Los Angeles to Pasadena Metro Blue Line Construction Authority
Los Angeles to Pasadena Metro Blue Line Light Rail Project

Value Engineering Study Report

Preliminary Basis for Design/Build Design

December 22, 1999

PROJECT: PASADENA BLUE LINE LIGHT RAIL PROJECT ALTERNATIVE NO. LAR-5
 DESCRIPTION: RAISE TRACK PROFILE FOR FIGUEROA STREET UNDERPASS SHEET NO. 1 of 9
 AND PLACE RESERVOIR UNDER TUNNEL

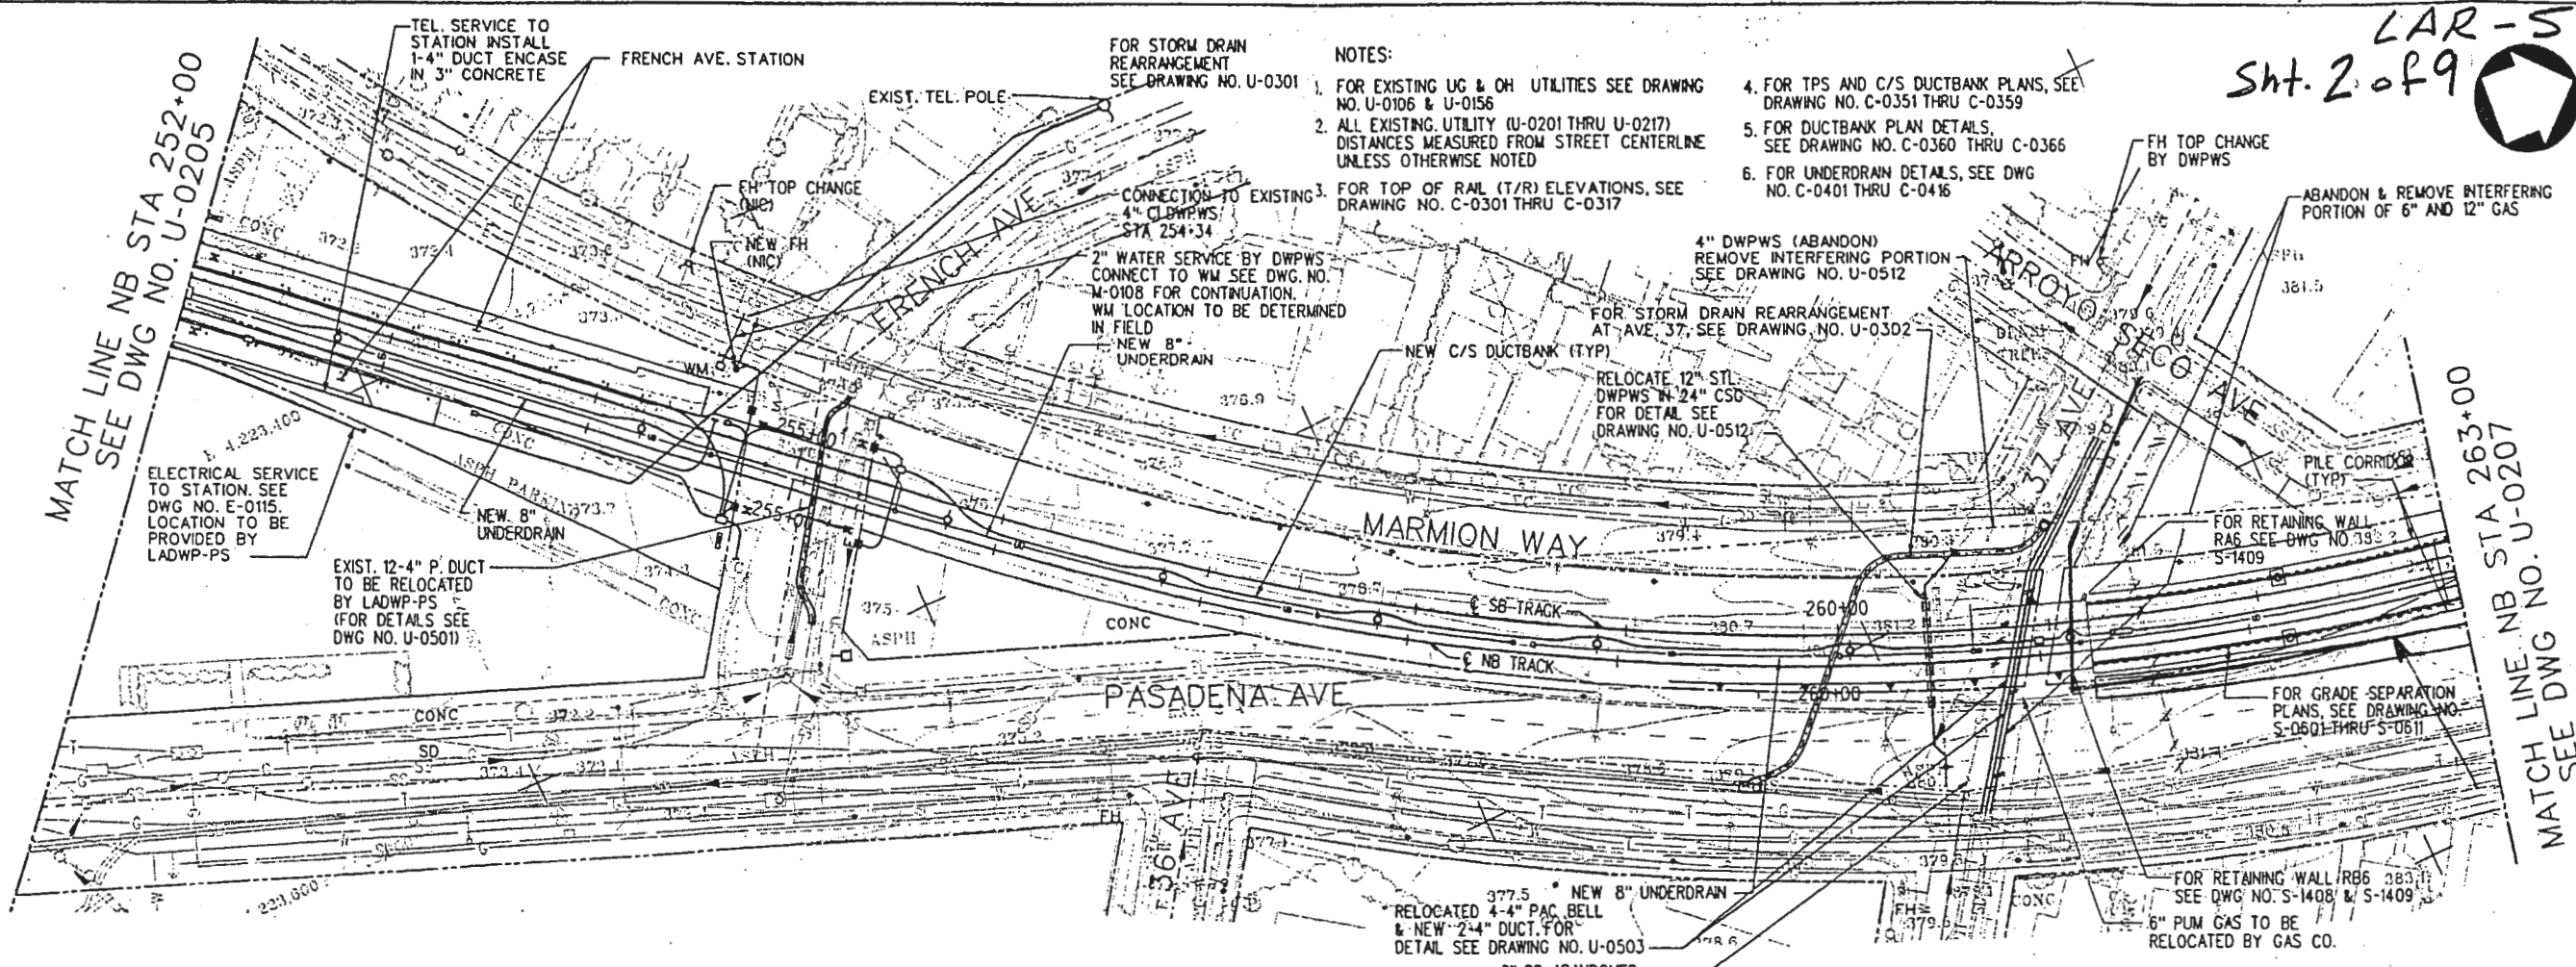
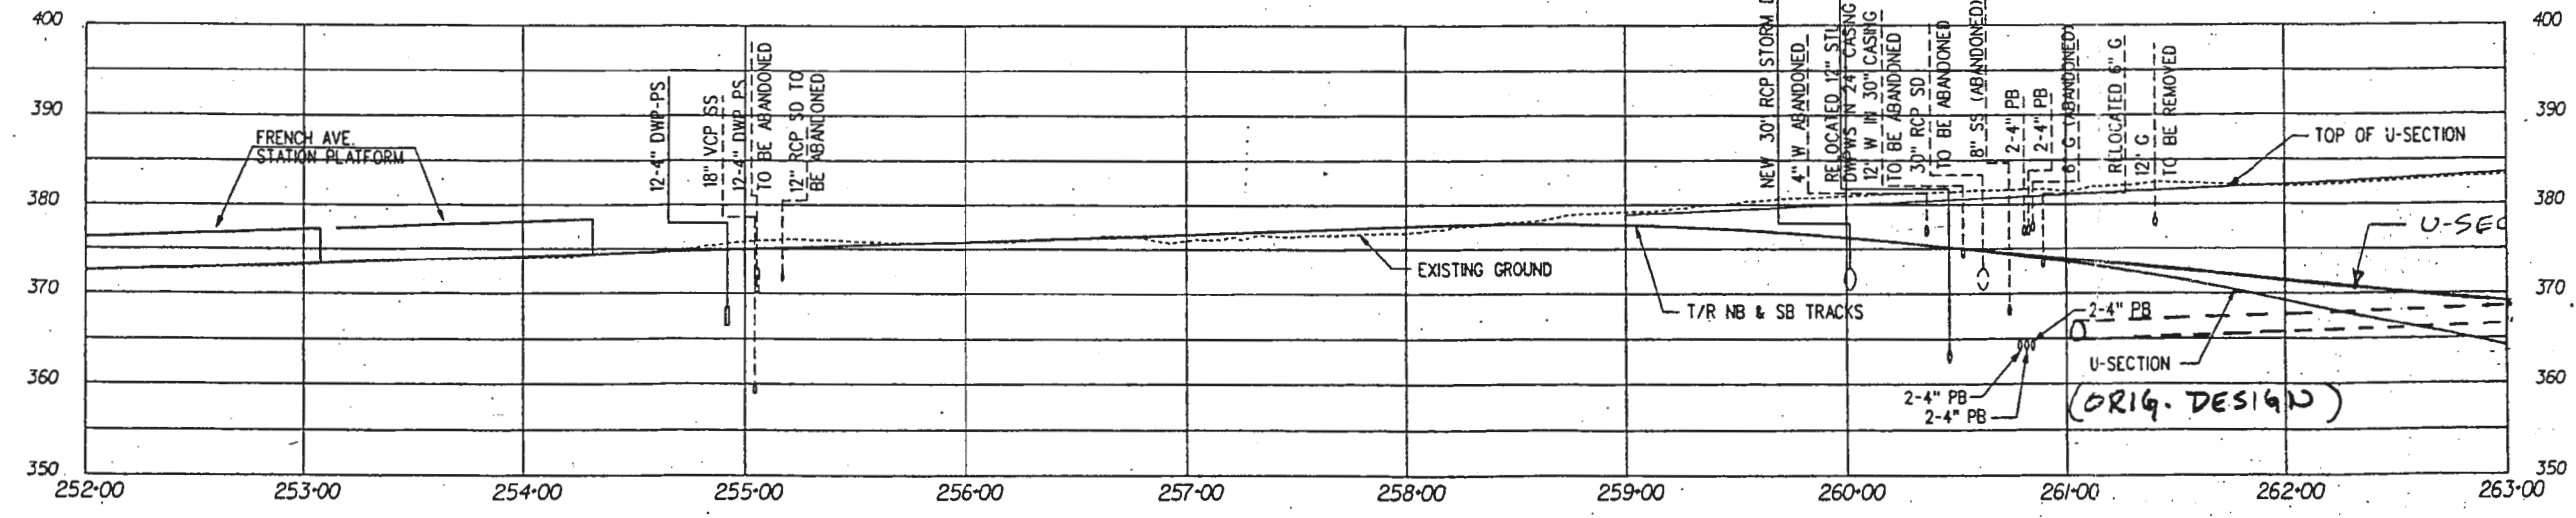
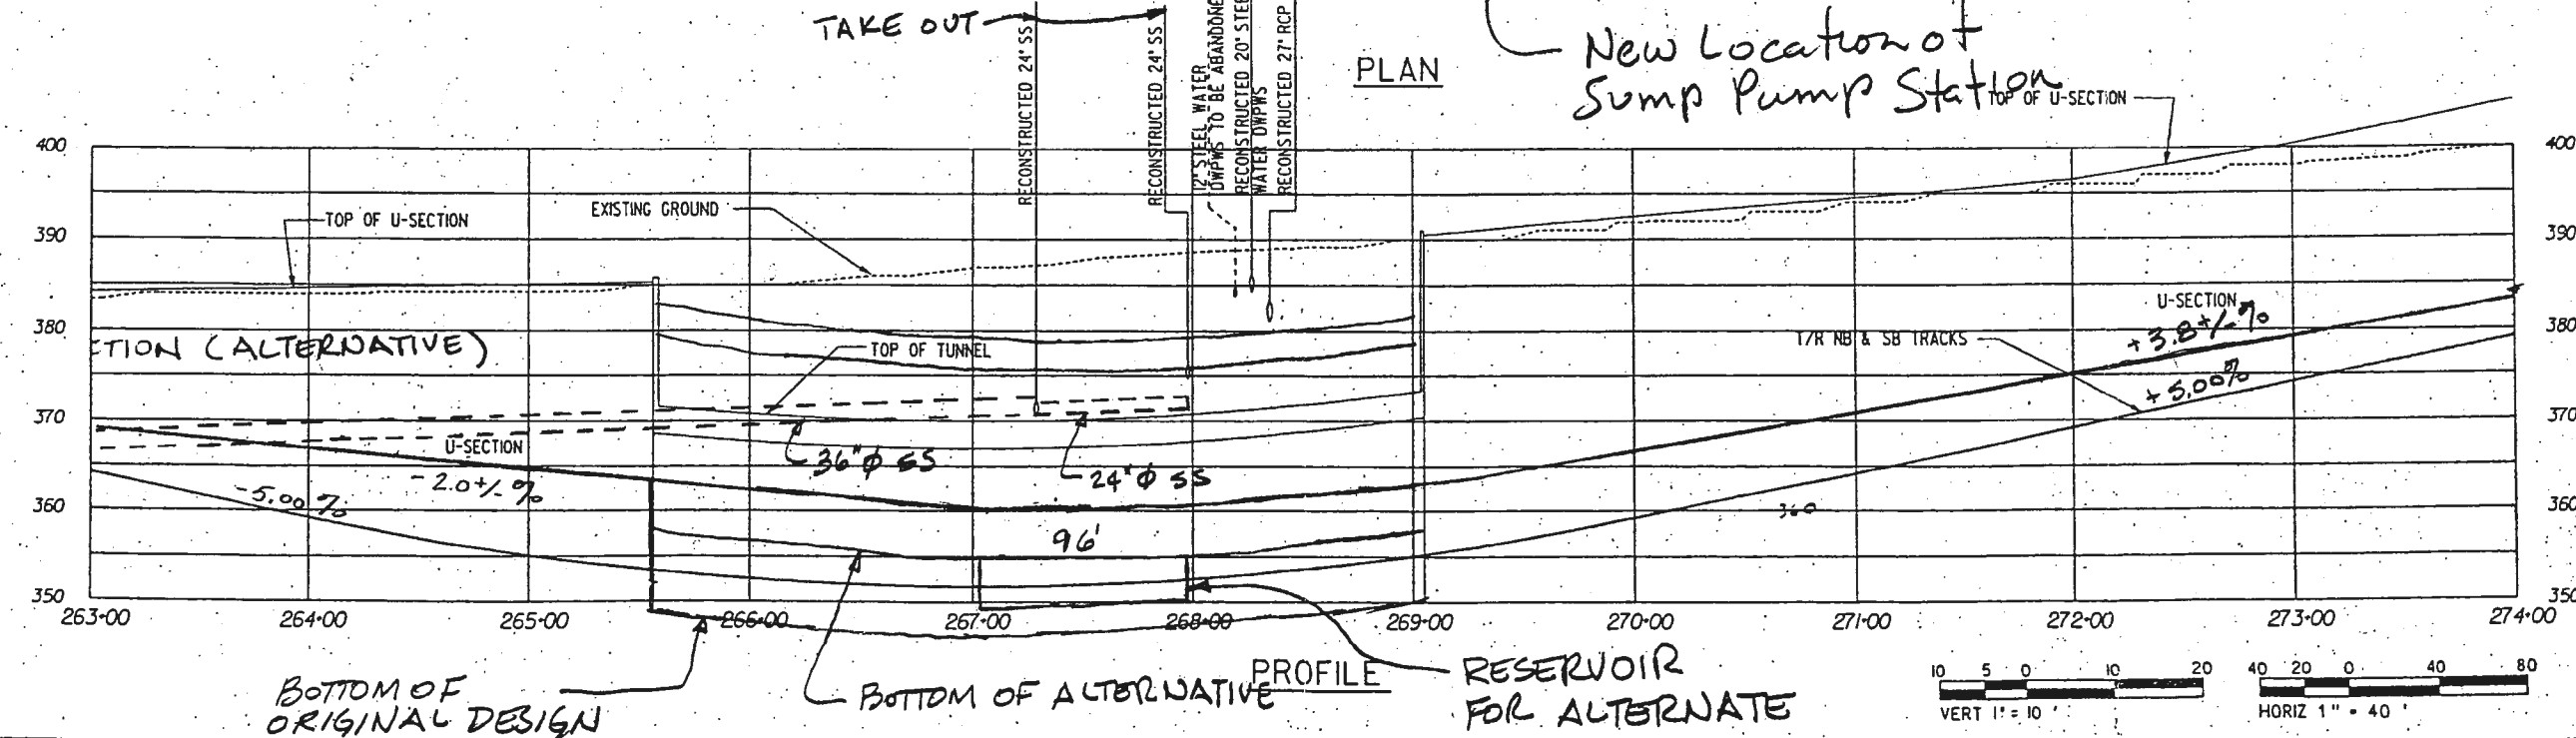
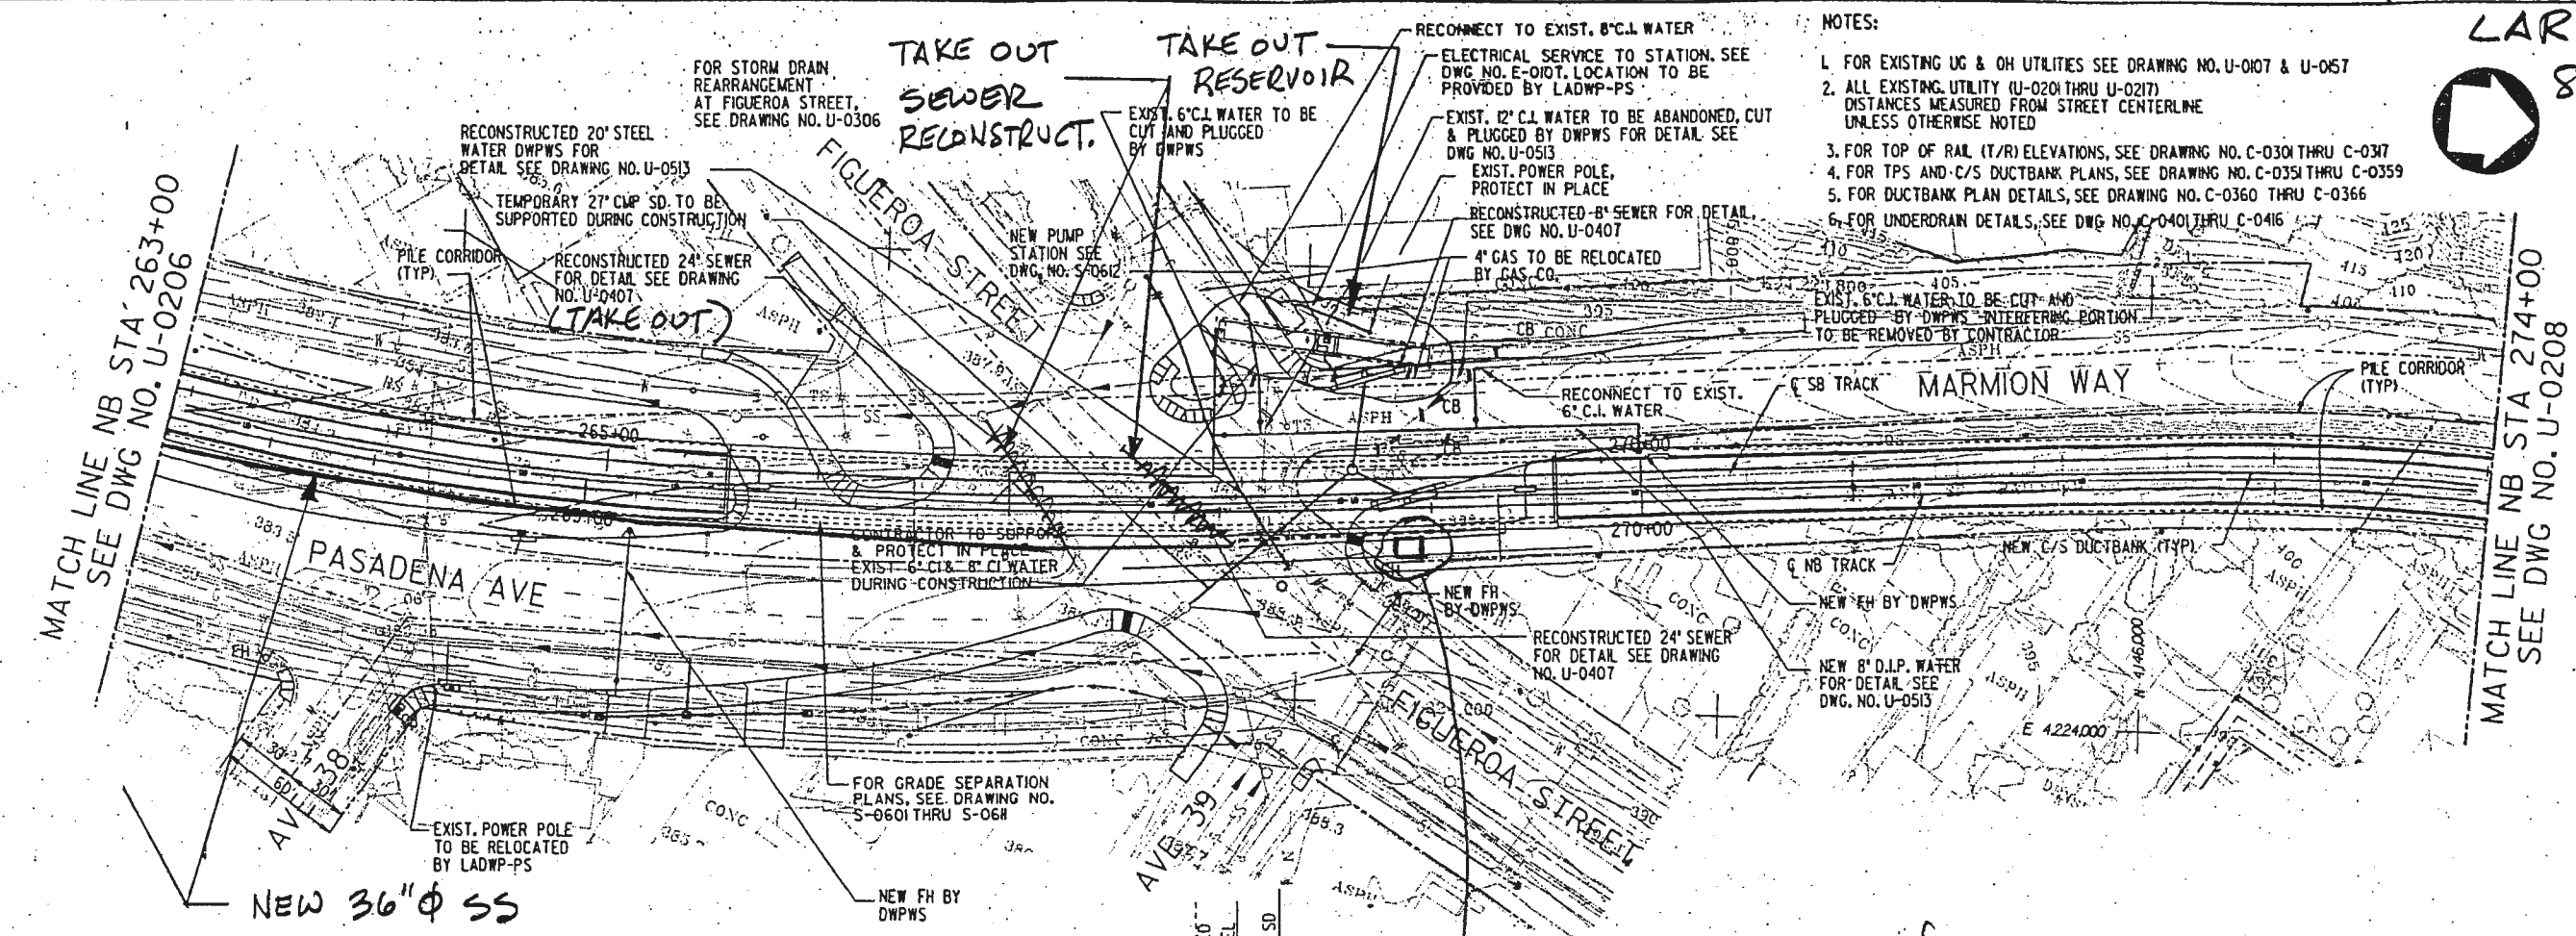
Intercept the two sanitary sewers on the cast side of the new grade separation box structure. Provide a 36-inch diameter sanitary sewer along the east grade of the tunnel and "U-Section" of the light rail line. Connect the sanitary saver line to the existing sanitary sewer at the intersection of Arroyo Seco Avenue and 37 Avenue. Raise the track profile so that the control for the box structure is the bottom of the 27-inch diameter storm drain in Figueroa Street. Reconfigure the storm water reservoir and place it under a portion of the tunnel. Locate the sump pumps station at the northeast corner of Figueroa Street and the light rail crossing.
